Service Manual

HONDA Genuine
6-DVD disc changer component

Model PH-2644B-E
(Genuine No. 39100-SJA-A010)
(ID No. 4XL2)

ORIGINAL SERVICE MANUAL

Main section

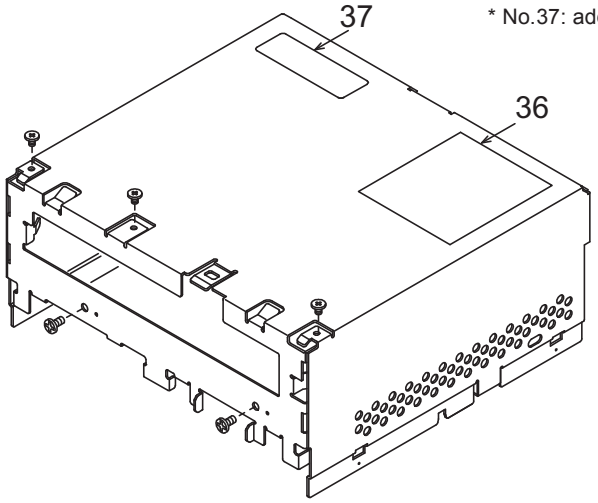
Difference the following parts in the parts list (page7,8)
Same parts depend on each model.
The model name is specified in the description.

NO.	PART NO.	DESCRIPTION	Q'TY
12	714-2606-8B	MACHINE SCREW (M2.6x6)	3
13	716-0878-50	IT-SCREW (M2.6x5)	1
14	778-3006-50	TAP-SCREW (3x6)	2
23	331-3858-02	MECH-BRKT	1
24	335-7275-01	FFC-HOLDER	1
26	929-2502-01	DVD CHANGER MECHANISM	1
29	714-2606-8B	MACHINE SCREW (M2.6x6)	12
30	714-3005-8A	MACHINE SCREW (M3x5)	2
31	716-0678-50	SPECIAL SCREW (M5x8)	3
32	716-0821-53	IT-SCREW (M3x5)	2
33	716-0878-50	IT-SCREW (M2.6X5)	4
34	716-3504-50	SPECIAL SCREW (M2.6x4)	3
35	731-3005-8A	TAPTIGHT (M3x5)	2
36	286-6491-02 286-6491-22	SETPLATE (PH2644BE) SETPLATE (PH2644BF)	1
37	285-1960-00	GUIDE LABEL (WMA)	1

* No.37: additional part
